**Consultation Response from Emma Mills
KC Landscape**

Application No:	2021/94280
Proposed Development:	Erection of 67 dwellings with associated works
Location:	land at, Lady Ann Road, Soothill, Batley, WF17 0PY
Applicant/Agent:	Self Architects
Planning Officer	Nick Hirst
Date Responded:	16.12.21 rev and highlighted 22.12.21
Responding Officer:	EM
Responding Ref:	KK139

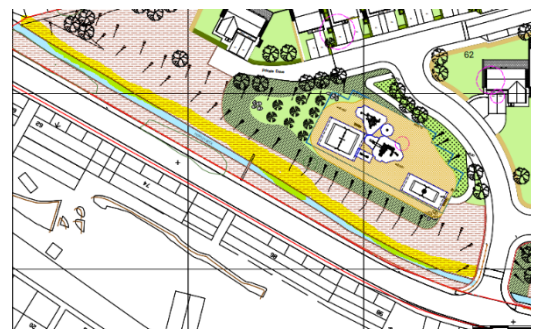
Setting – this layout for 67 dwellings retains the large swathe of existing natural vegetation along the beck which is welcomed. Welcome retention of existing trees in the site, however opportunities to extend this green infrastructure through tree planting in adjacent gardens appears to have been missed.

Howley Beck runs through the proposed Public Open Space, clarification as to the delineation/measures to ensure that there is a clear definition of the water course in the residential amenity for safety of the users of the adjacent children's play (bearing in mind some youngsters might not read signs).

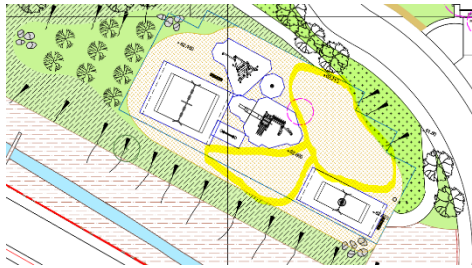
Play area layout – not sure this is the final design or indicative. A couple of queries about siting and location of proposed benches and equipment, this bench is in potentially blocking half of the access path.

Bark is shown as the safety surface – has DDA accessibility been considered? Bark is difficult to push wheelchairs and push chairs across, some more accessible areas would be beneficial to encouraging use by all abilities. There is a potential for this play area, with its play bark surface, to suffer in terms of useability due to potential poor drainage or becoming waterlogged in extreme wet weather being located adjacent to the Beck. Wear pads will be required under the swing, slide, see-saw, roundabout, etc.

Why is there such a large area of empty bark? Could this be a grassed informal kickabout area?

Good range of pieces of equipment included, compliments the offer in the vicinity, however, we would recommend this is metal play equipment in this location for durability (one of the pieces looks like a timber log stack climber with nets – is there a metal version?). Equipment appears congested in one area to the south – is there a reason for this?
